December 18, 2020

RE: **Lot 12 Block 5 Volcano Cliffs Unit 19 SAD 228
6511 Azor lane NW
Grading and Drainage Plan
Engineers Stamp Date 8/20/2020 (D10D003H12)
Pad Certification Date 12/16/2020**

LOT12 BL5 U19 VOLCANO CLIFFS 6511 AZOR LANE	DRAWN BY DEM
	GRADING AND DRAINAGE PLAN	DATE 8-20-20
8/20/20		SHEET # C1
DAVID SOULE P.E. #14522	1608 CENTRAL AVENUE SE SUITE 201 ALBUQUERQUE, NM 87106 (505) 972-0899	JOB #

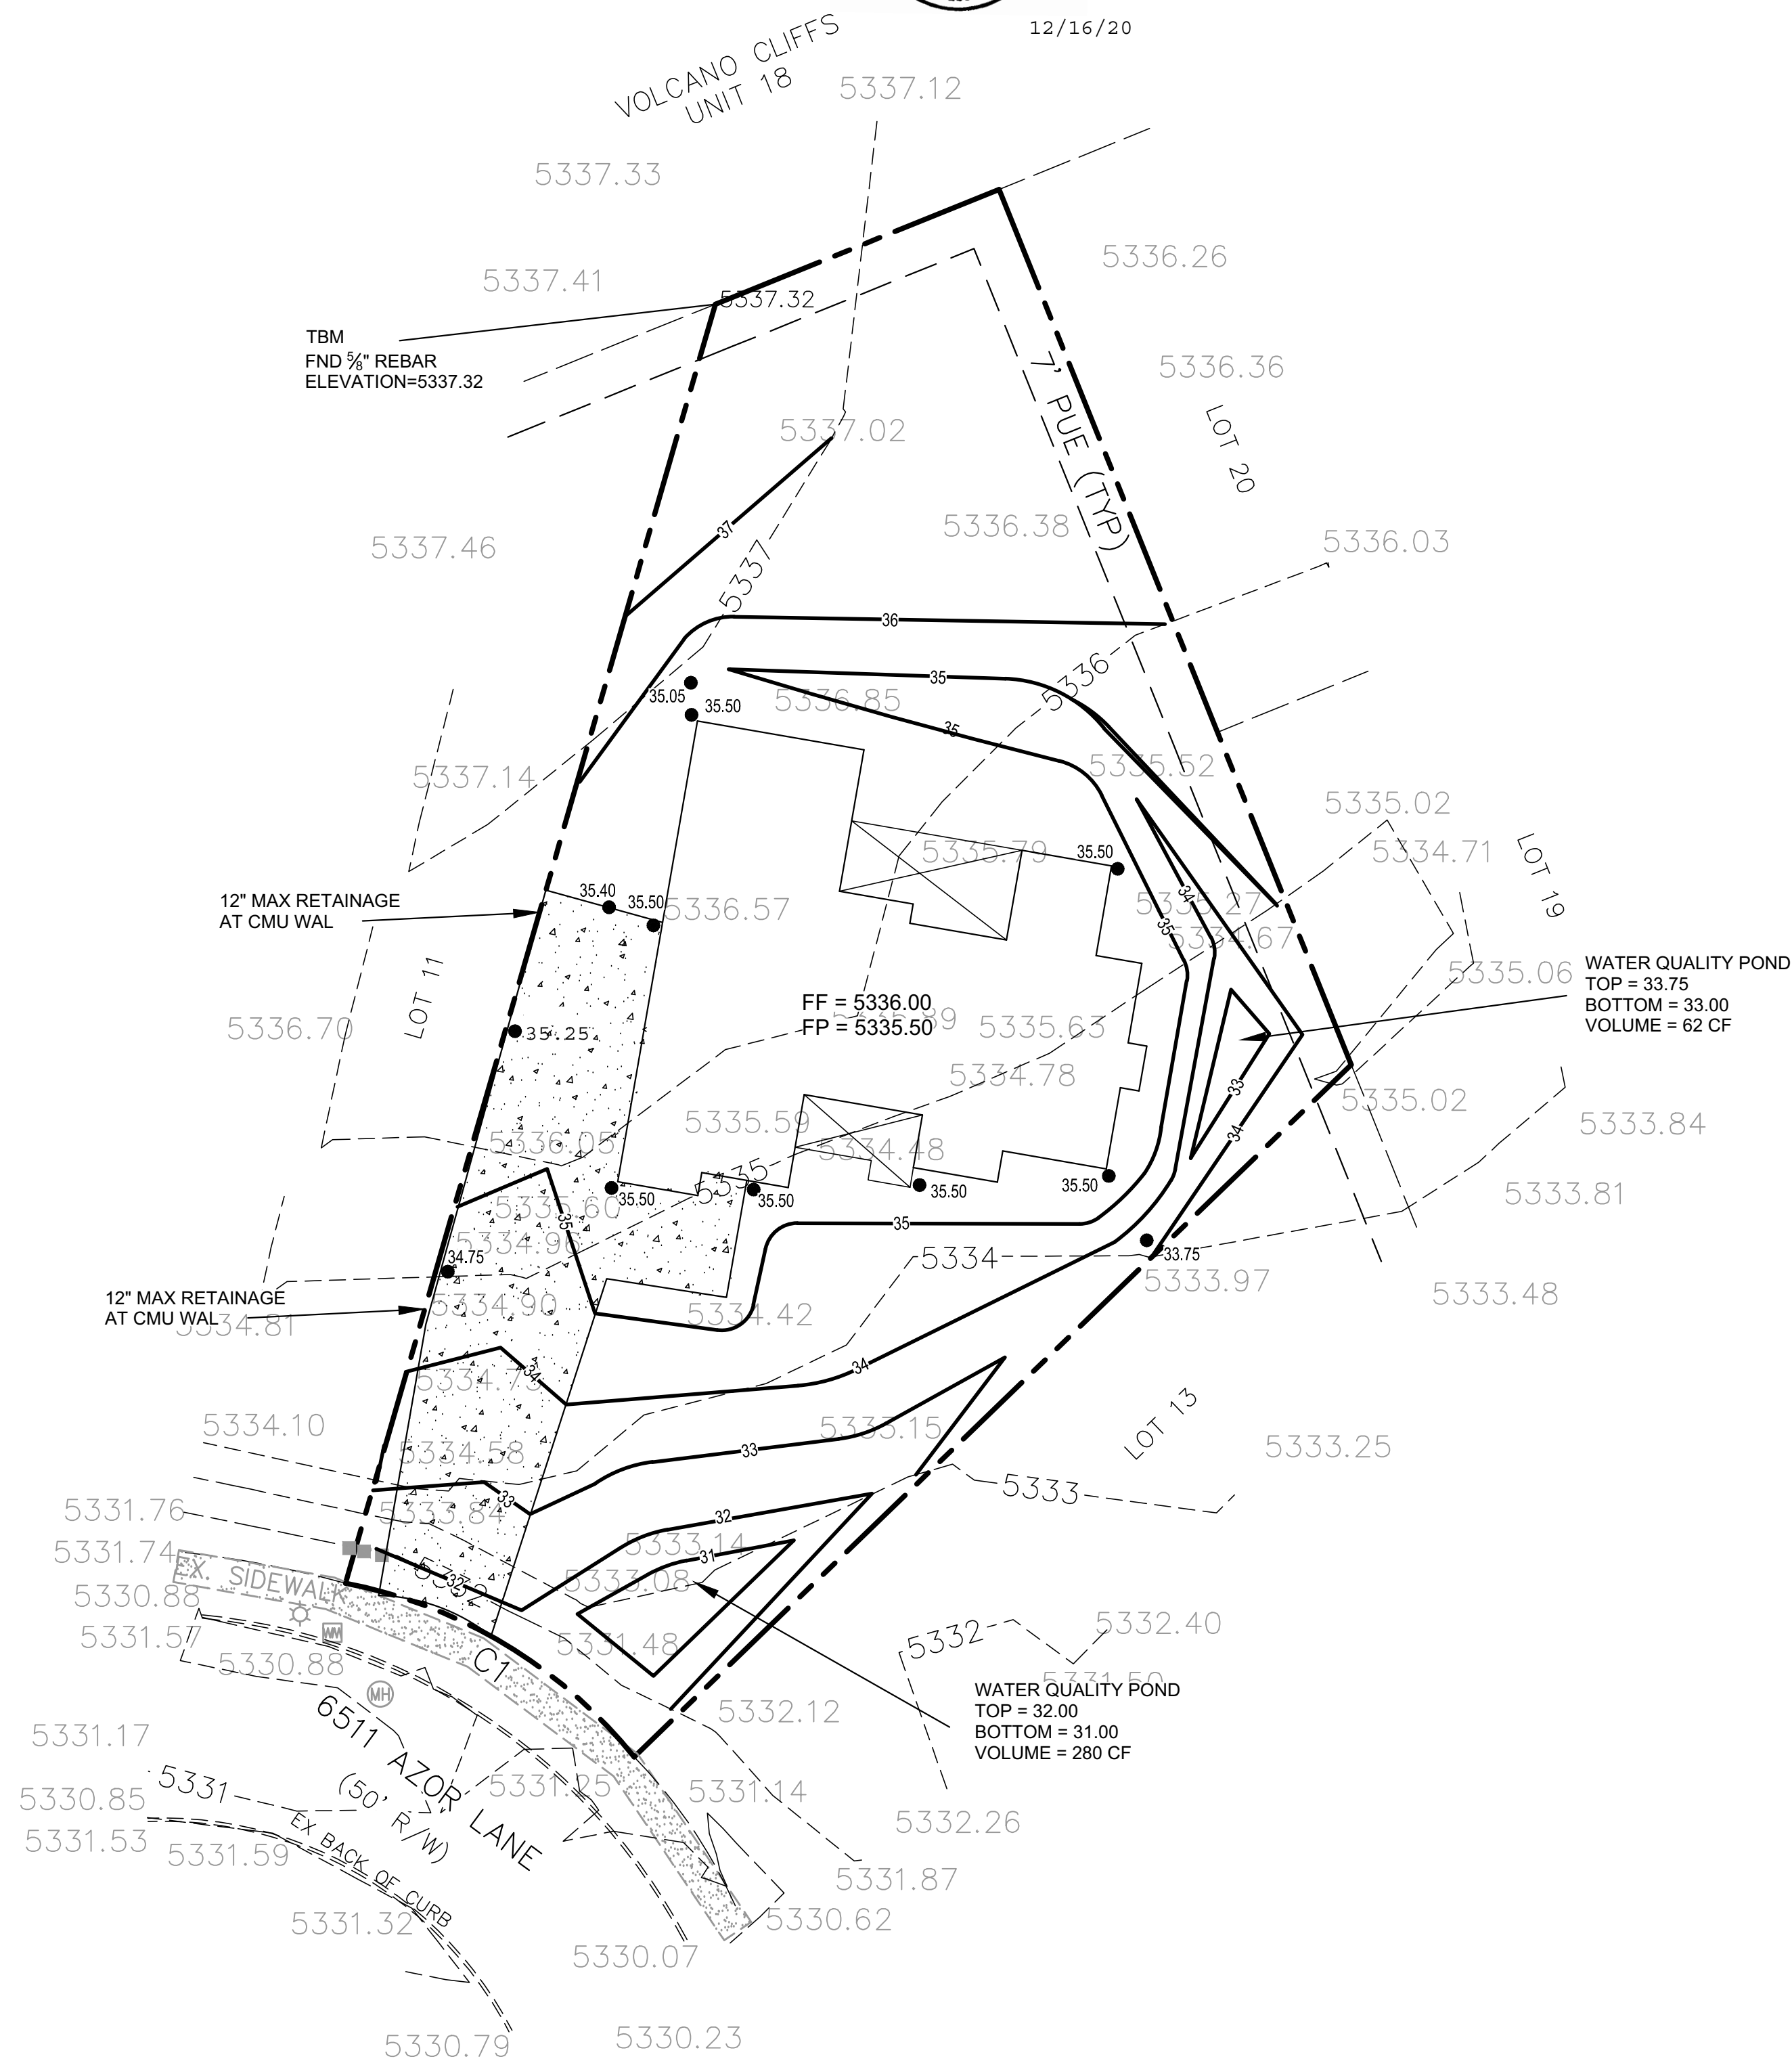
Based upon the information provided in your submittal received 12/17/2020, this plan is approved for Building Permit.

Reiterate to the Owner/Contractor that a separate permit for a garden/retaining wall must be obtained, with the approved G&D plan and Pad Certification. Also, let the owner/contractor know that if a pool is to be added in the future the G&D plan will need to be modified showing the location of the pool and the land treatment differences.

Prior to Certificate of Occupancy release, Engineer Certification per the DPM checklist of this plan will be required.
